**Clicking Noise From Front of Vehicle –  
Brake Disc Dust Shield – Install Revised  
Dust Shield****MODEL** 1995-96 MY  
Sedan Range  
**VIN**  
720001-ON**ISSUE:**

ILLUSTRATION 1

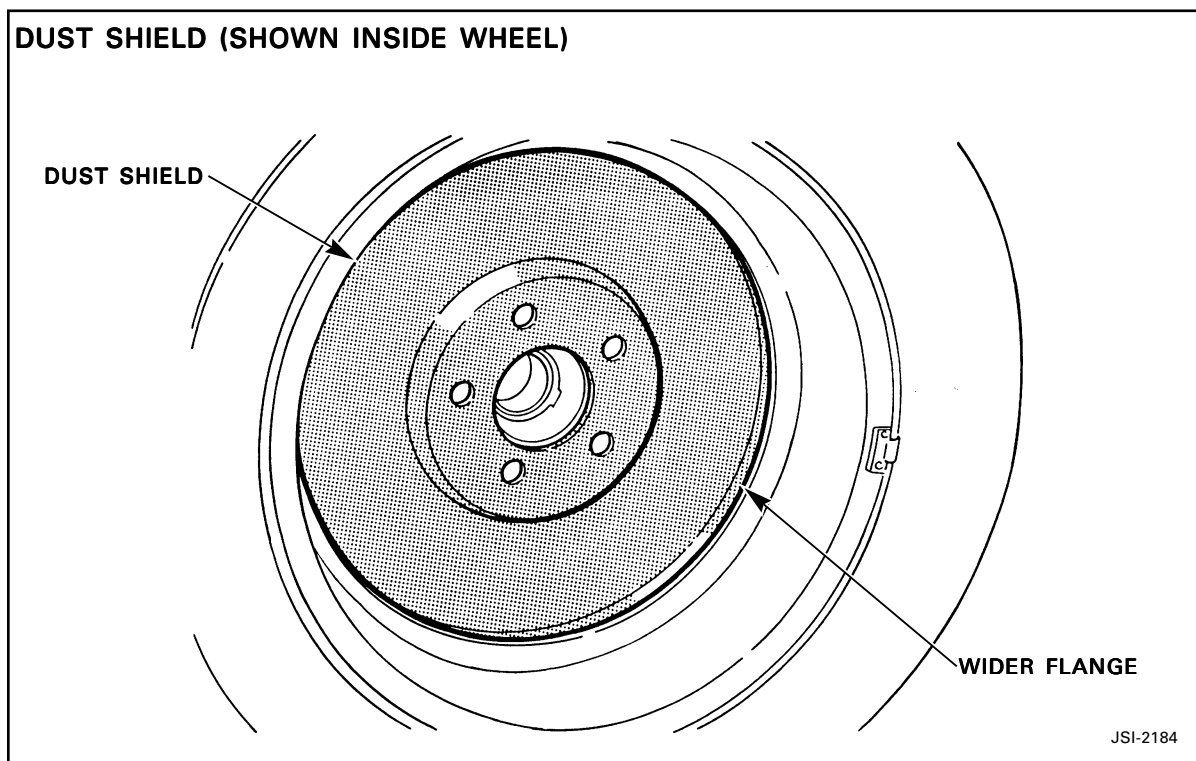
Some 1995-96 MY Sedan Range vehicles equipped with 16 inch alloy wheels **and** accessory dust shields (Illustration 1) may experience a clicking noise from the front of the vehicle at low speeds. The noise may be caused by one dust shield rubbing against the alloy wheel.

After verifying a customer complaint of clicking from the front of the vehicle, determine on which side of vehicle the noise is apparent. Replace the dust shield on that wheel with a revised dust shield. In addition to the part number label, the revised dust shield can be identified by a wider flange with foam rubber blocks attached.
